USEPA, Region 9
AMCO Chemical Superfund Site
Oakland, California

**Attachment 9 - RESPONSE TO COMMENTS on the
Final Engineering Evaluation and Cost Analysis (EE/CA)
AMCO Superfund Site, Oakland, California**

Comments 40-83 present EPA's Response to Comments (RTCs) to written comments submitted by John Schweitzer on 26 February 2015. The original comments were submitted as an annotated copy of the EE/CA to EPA. The transcribed comments are given below:

**ATTACHMENT 5
Soil Sampling Results and Combined Plume Map January 2014
Source Area (Former AMCO Facility)
December 2011 - January 2012**

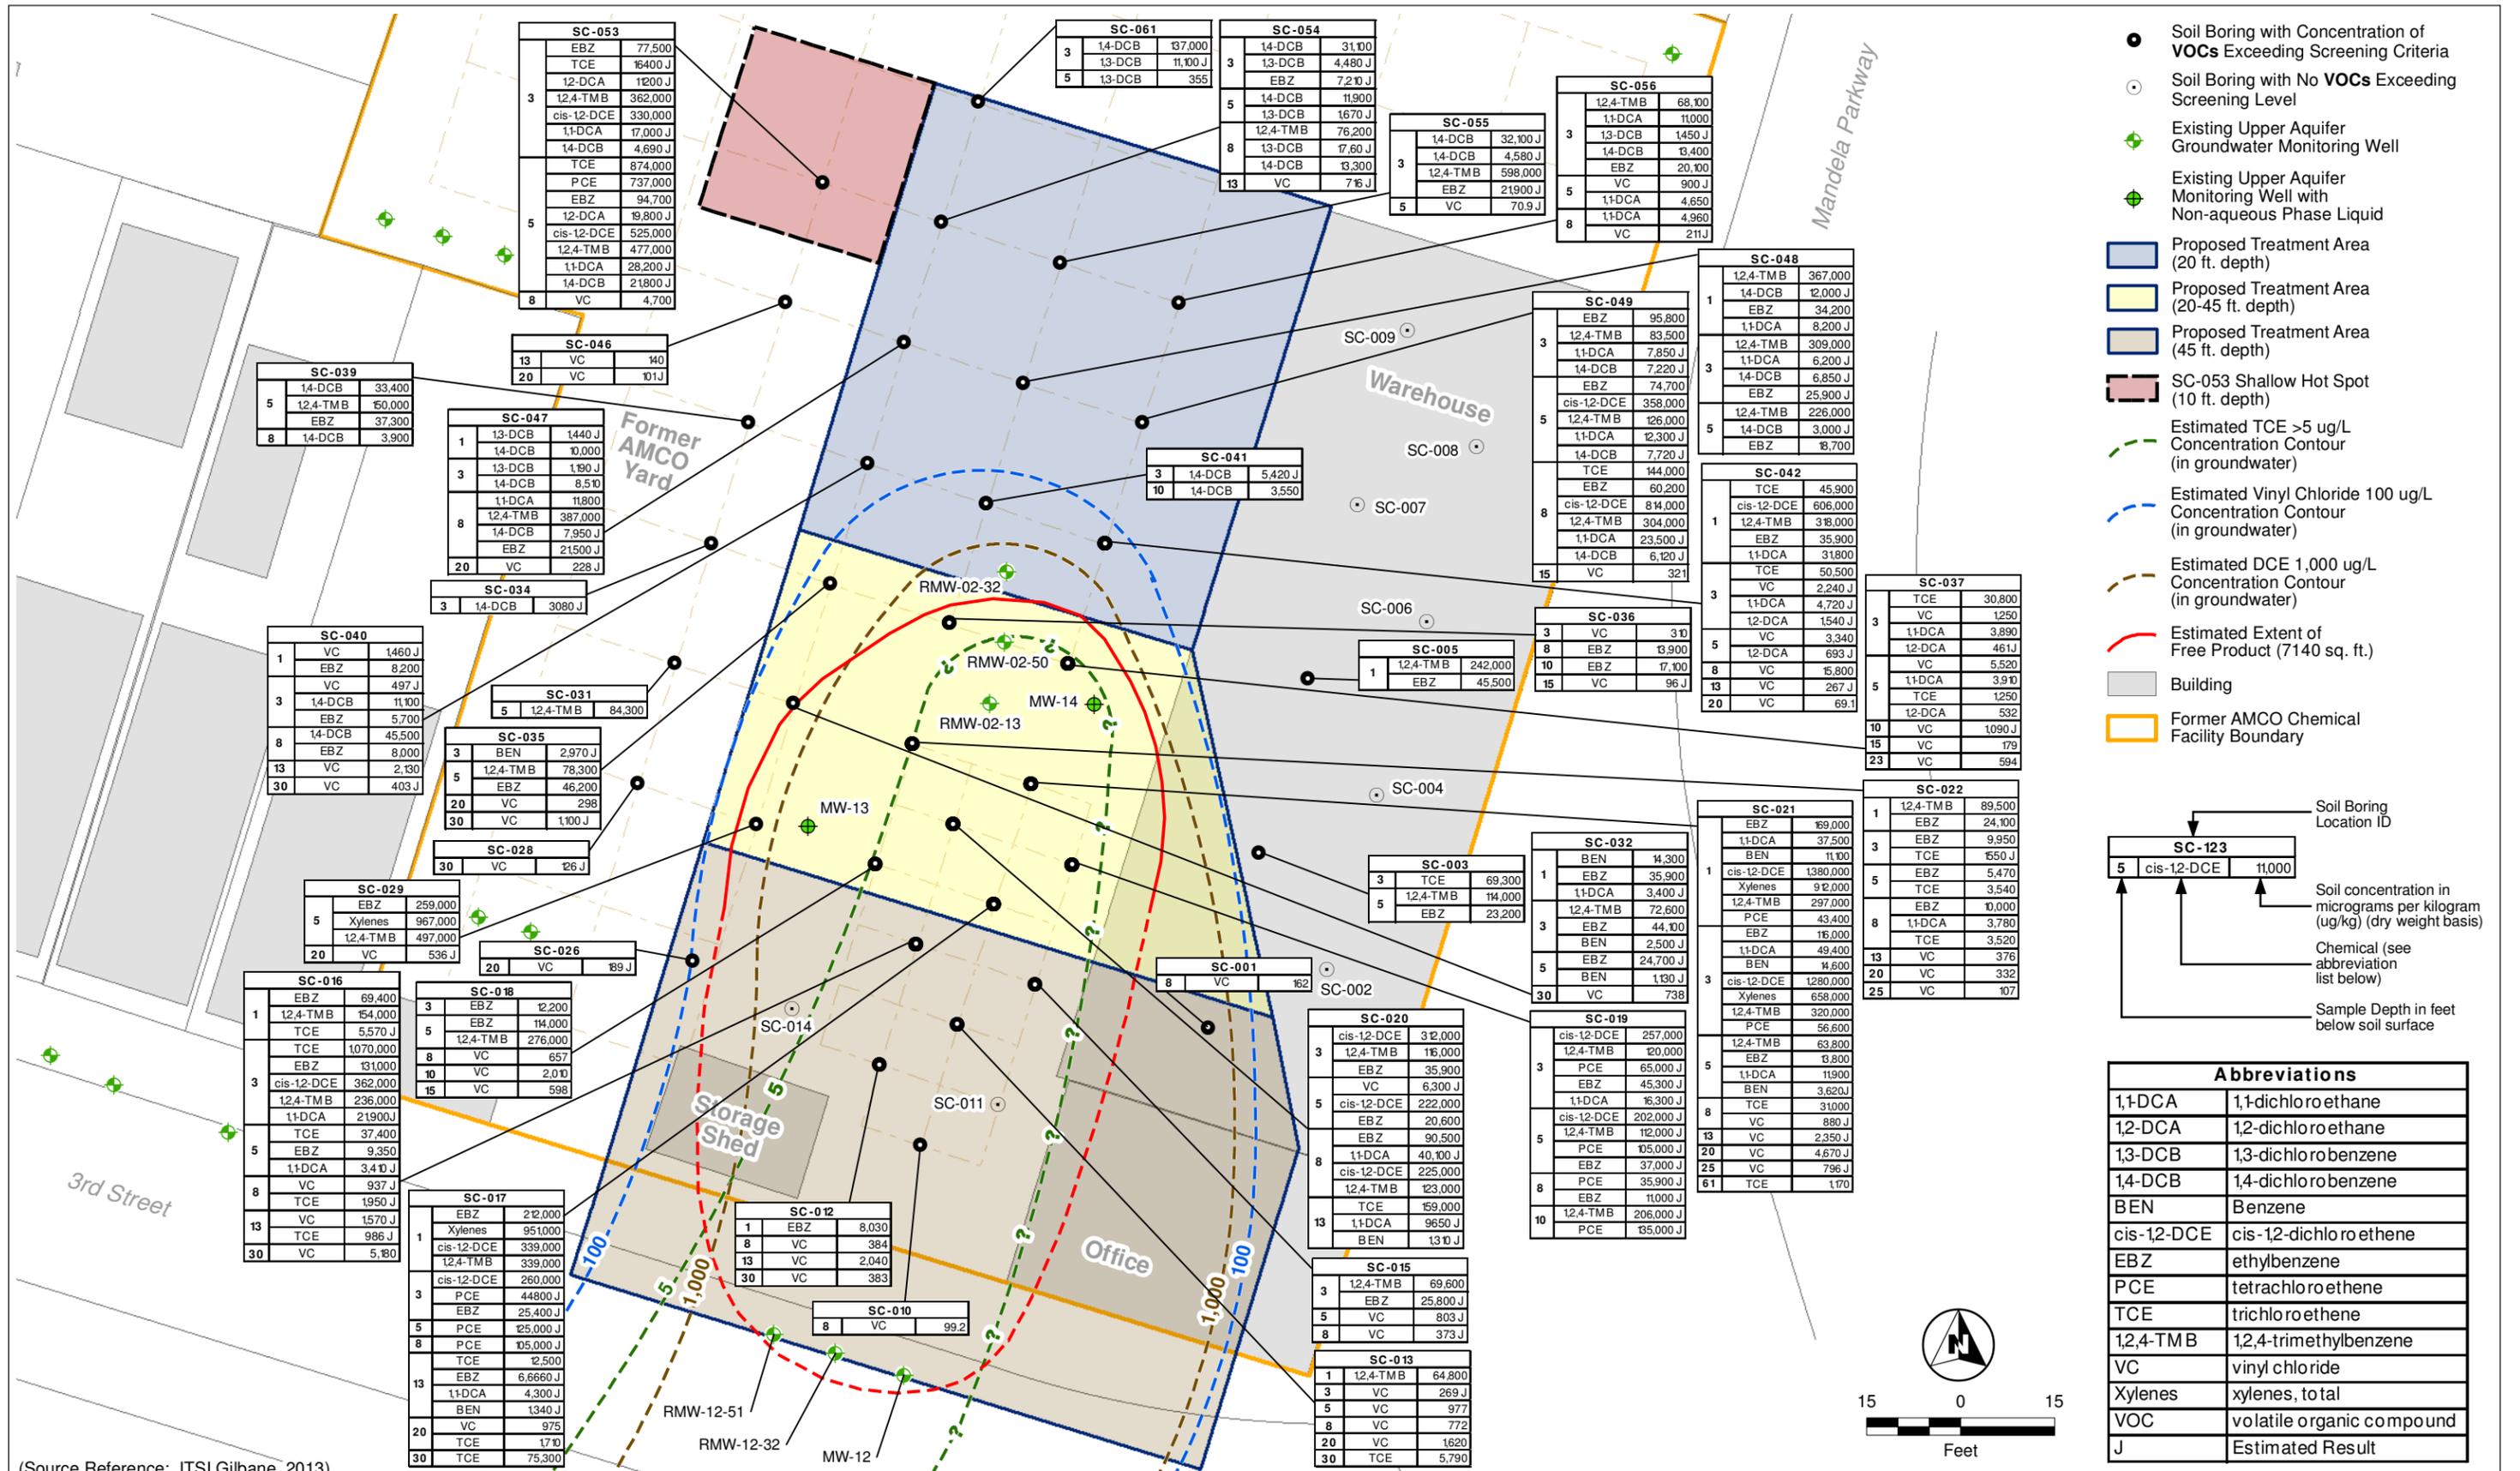
No.	Comment Made By:	Comments and Recommendations	Response
23	John Schweizer	<p>Comments are derived from written notations made to the EE/CA Figure 2-2, <i>Soil Characterization Sampling Grid and Concrete Thickness</i>:</p> <p>a: A red square is drawn in the northwest corner of the proposed treatment area which is larger than the treatment area proposed in the EE/CA. The caption reads "Down to 45' top of sand (Middle Zone Source)".</p> <p>b: A red, irregular shape is drawn in the central area of the proposed treatment area which is significantly smaller than the treatment area proposed in the EE/CA. The caption reads "Down to 35' (Middle Zone Source)".</p>	<p>The purpose of this NTCRA is to reduce the potential for vapor intrusion (VI) at the Site. Volatile organic compounds (VOCs) in the soil, groundwater and light non-aqueous phase liquids (LNAPLs) are the source material for VI.</p> <p>The red outlines are smaller treatment areas that seem to rely on groundwater data alone; the selected treatment area relies on groundwater as well as the results of a very intensive soil characterization investigation. EPA's more conservative approach will better ensure that residuals that could re-contaminate the cleaned up area are not left behind.</p>
